ADDENDUM 5

Date: 01/22/2026

Project Name: Coushatta Education Building

Project Number: 24.0002607.000

A1 ARCHITECTURAL SITE PLAN - OVERALL
AS1.01 1" = 30'-0"

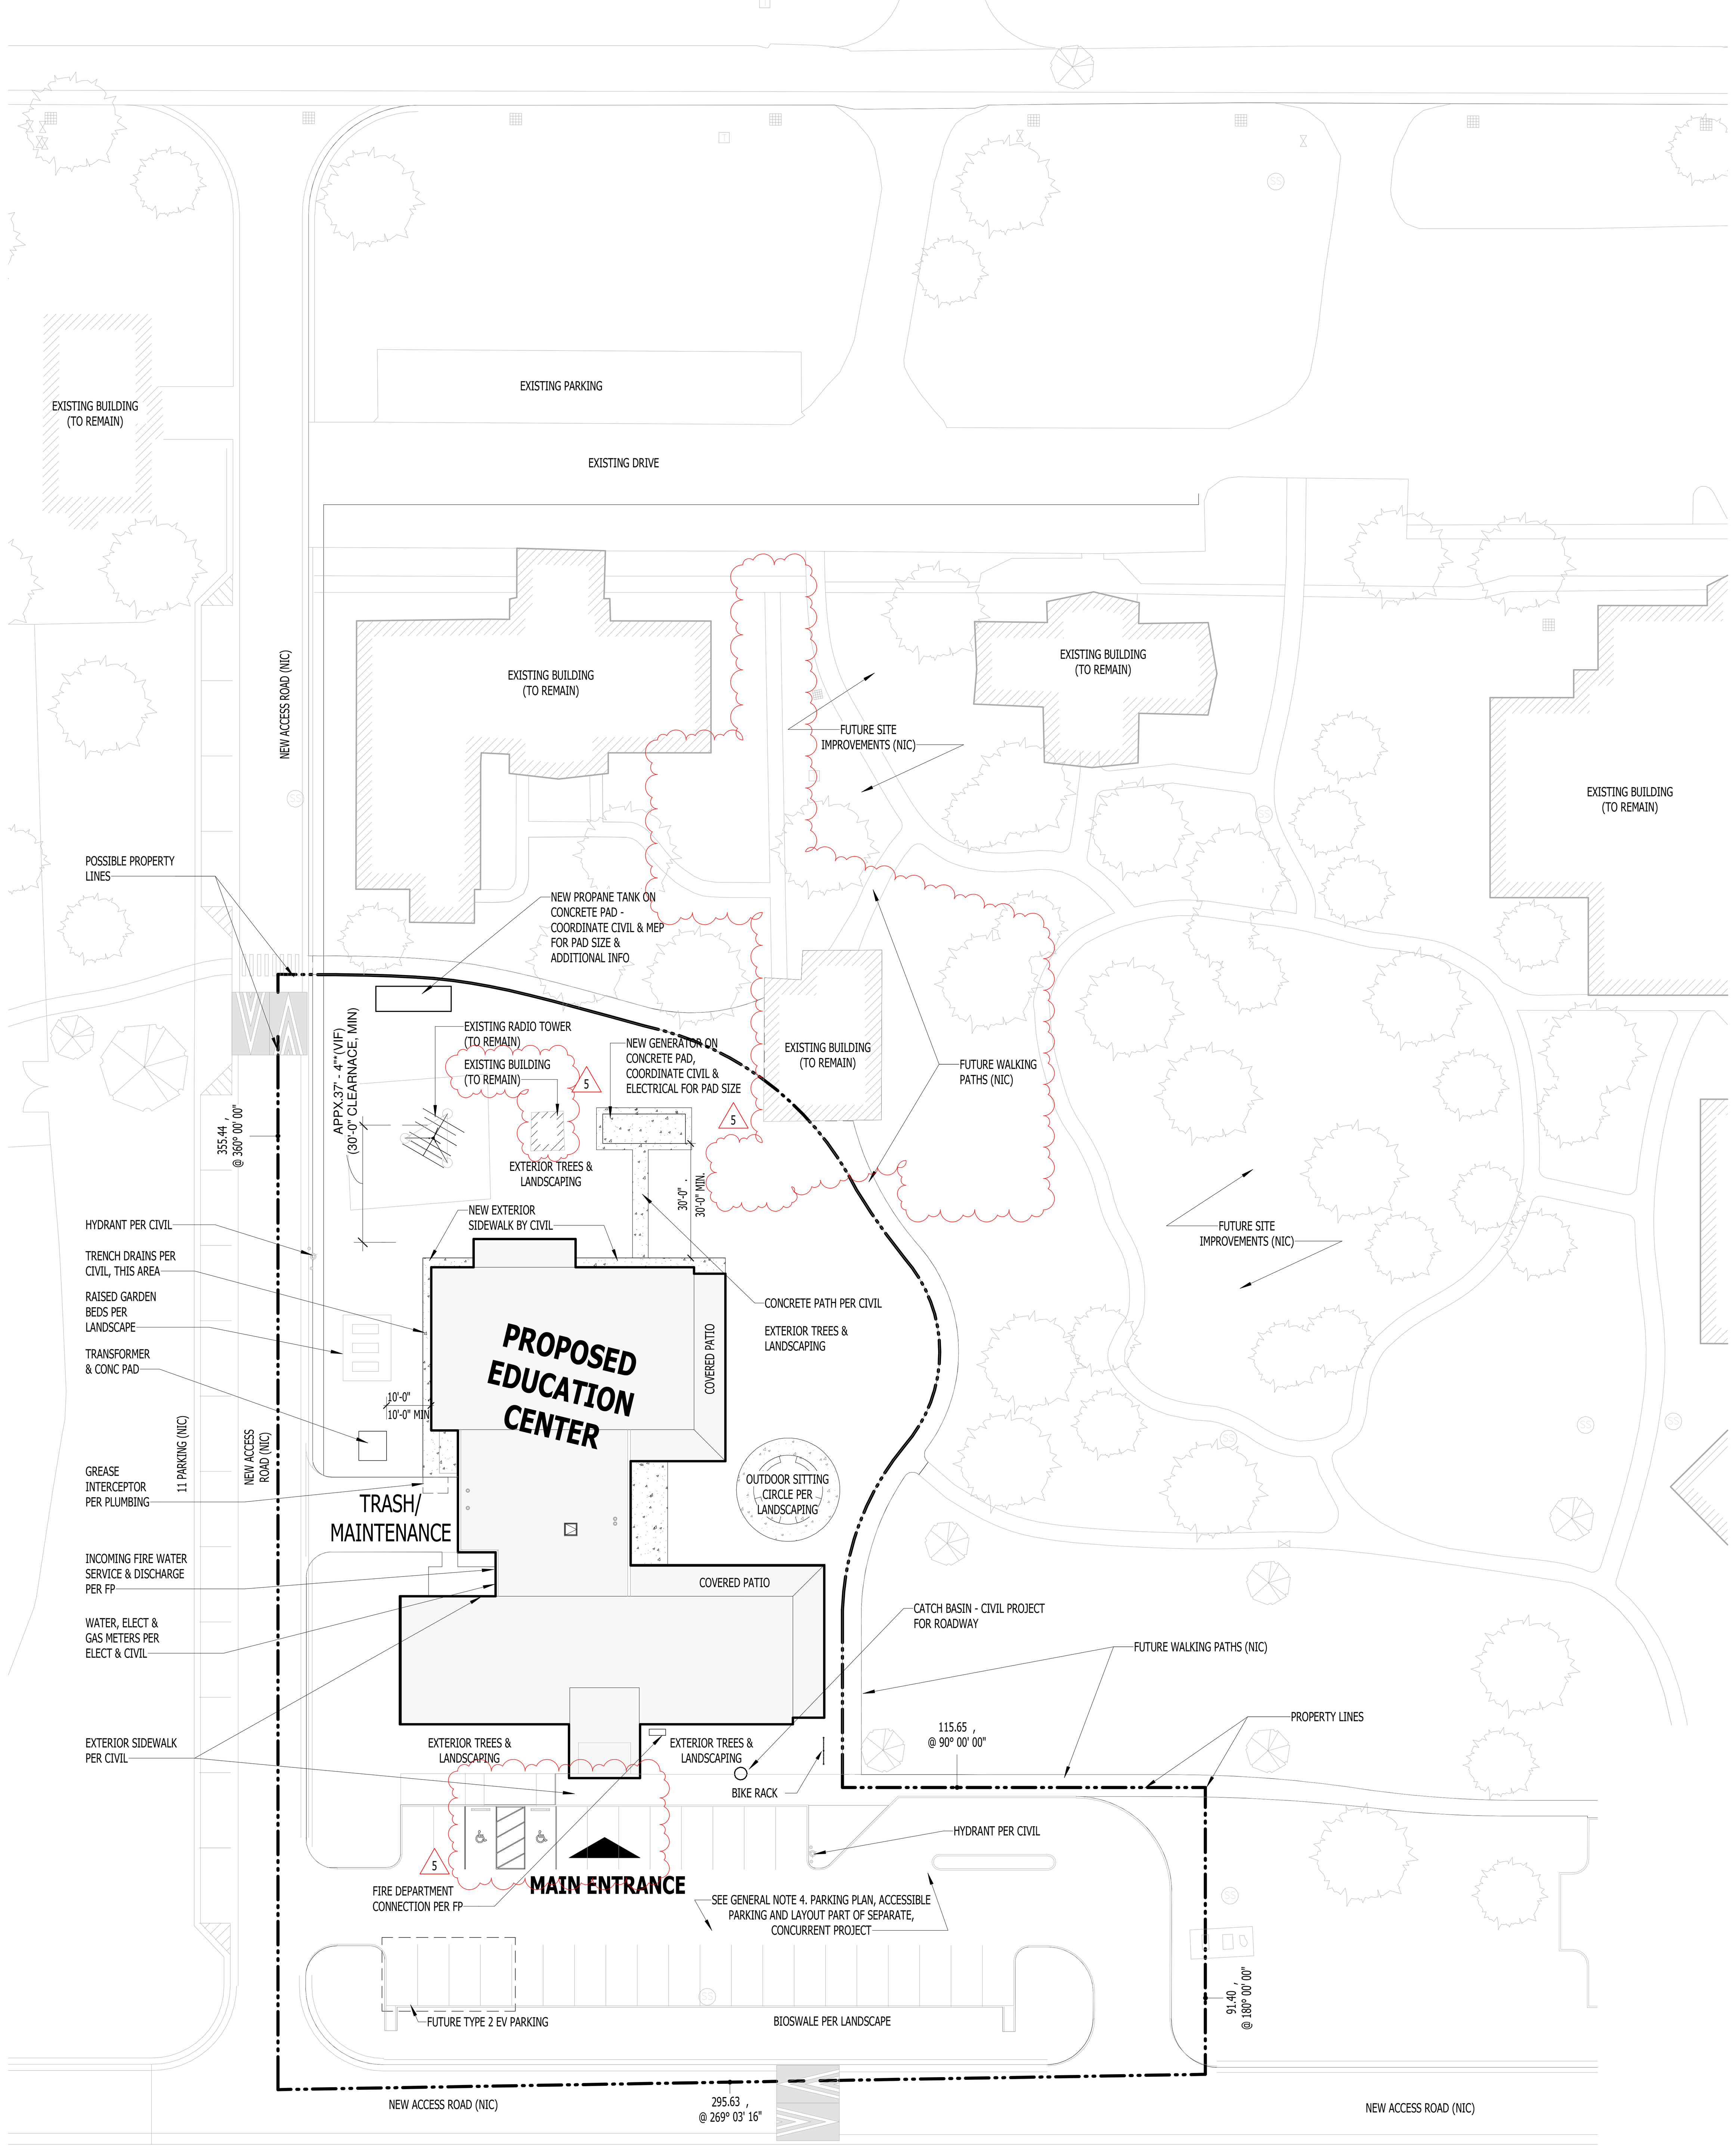
Sheet AS1.01 – Overall Site Plan
1. Update 1/AS1.01 to clarify propane location per other discipline sheets. Update ADA parking layout as indicated.
2. Remove detail 5/AS1.01.
3. Update 2/AS1.01.
4. Add Parking Key note 6 referring to new Civil sheet C6.02.

A1 REFLECTED CEILING PLAN - OVERALL
A03.01 1/8" = 1'-0"

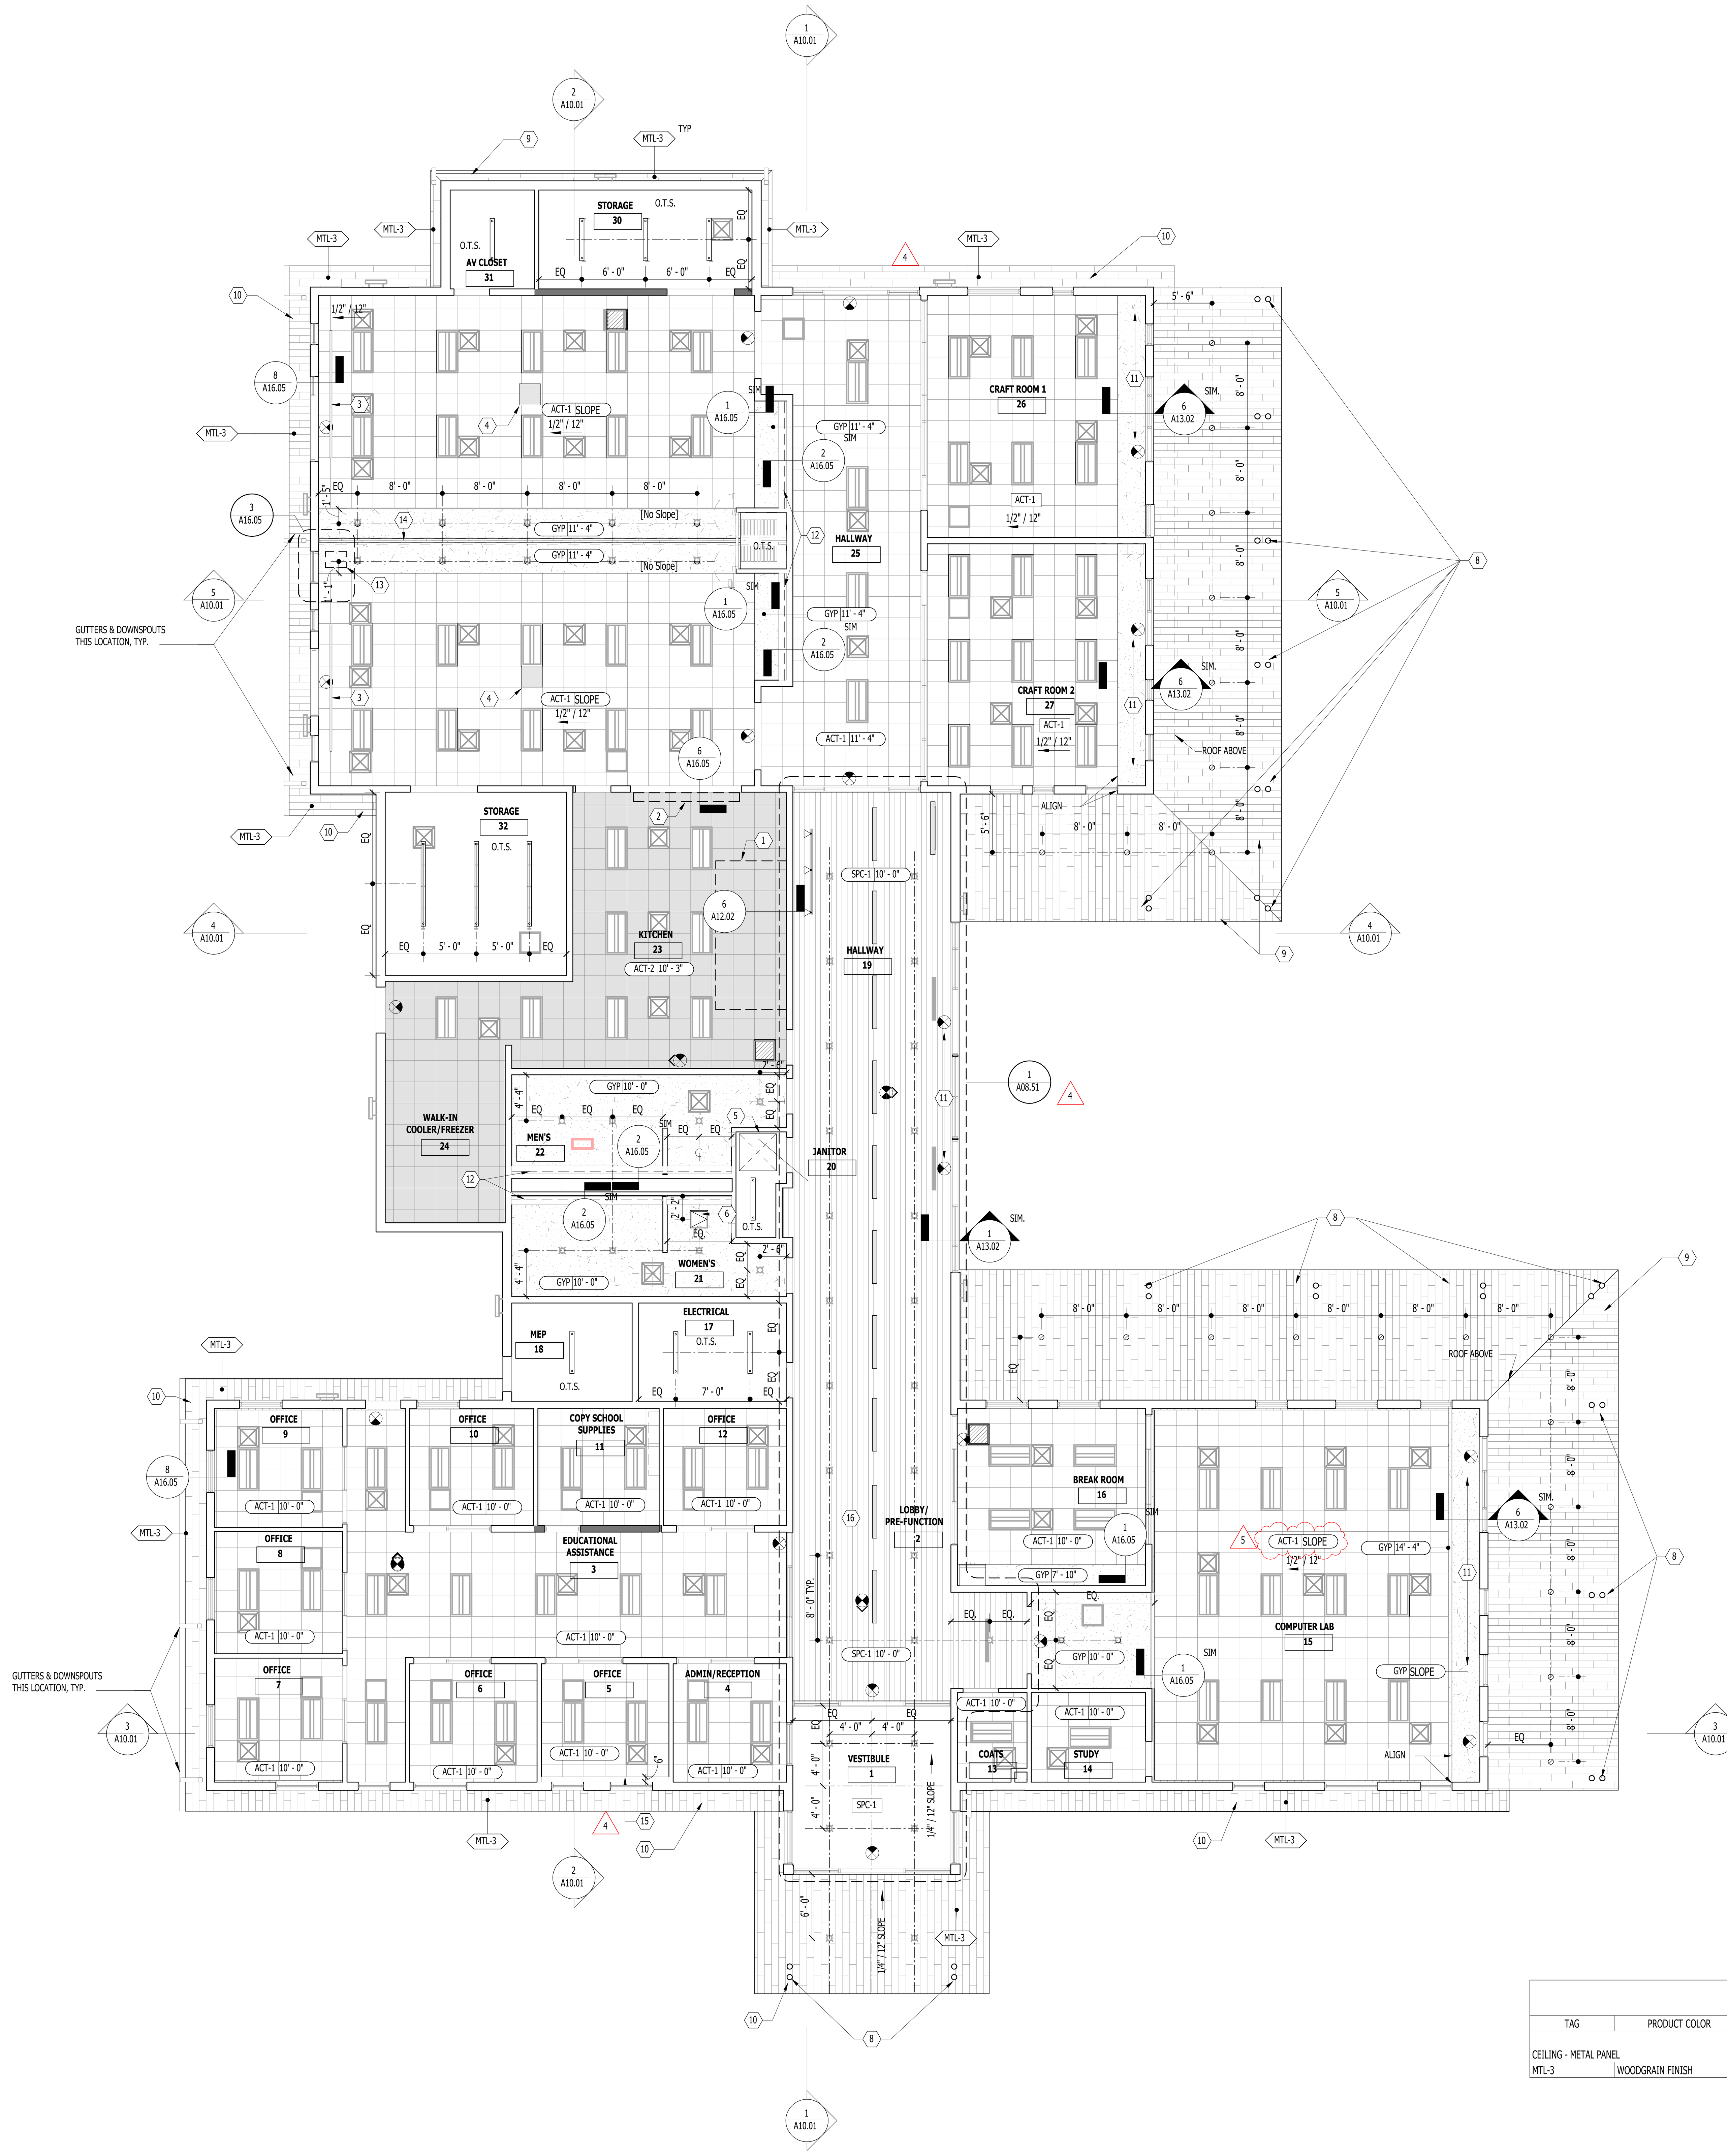
Sheet A03.01 – Reflected Ceiling Plan Overall
1. Add Finish tag to Computer Lab 15 on A1/A03.01.
2. Add Keynote 16 to RCP Notes by Number for wood slat ceiling coordination.
3. Update return and supply grille graphics on RCP Legend.

3 ELEVATION- EXTERIOR- EAST
A09.01 1/8" = 1'-0"

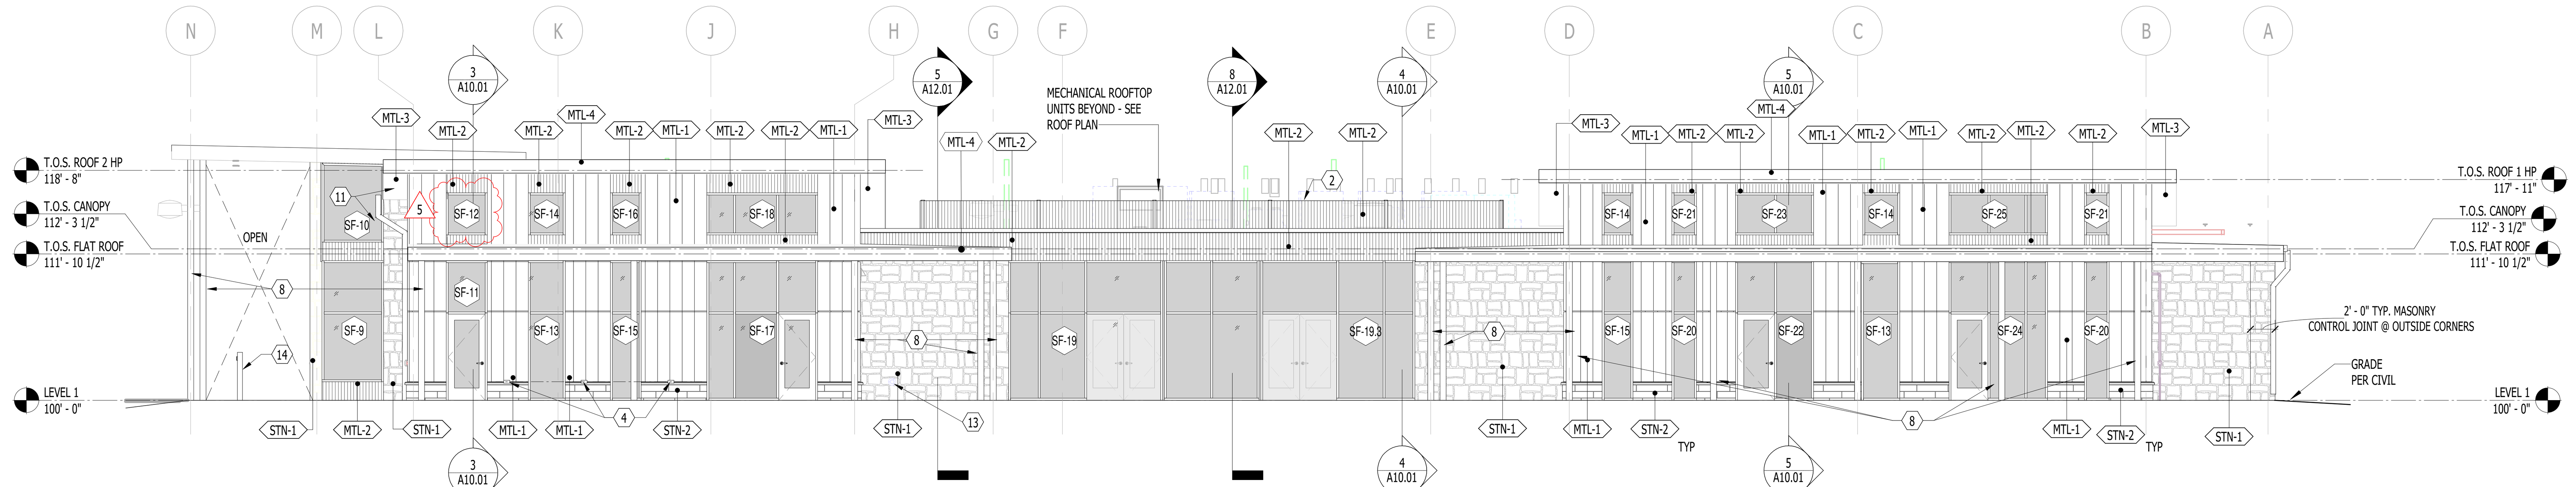
Sheet A0-9.01
1. Add window tag SF-12 to 3/A09.01 East Elevation at upper plan left above at clear story area.

SF21 calls for EG1 glazing. Please define EG1	Ignore EG1 as a typo.
East Elevation. 1 window not labeled	The unlabeled window on East elevation is SF-12.
Interior doors hold 1/4" glazing not 1/2". Is this acceptable?	1/4" is acceptable and is noted as such in 08 80 00 Glazing 2.07.C.1
Interior frames call for 1/2" glazing. Glazing rubber for flush glaze frames can accept no thicker than 3/8" glass. Is	GL-2 on Sheet A17.21 should be updated from 1/2" glazing to 1/4". 7
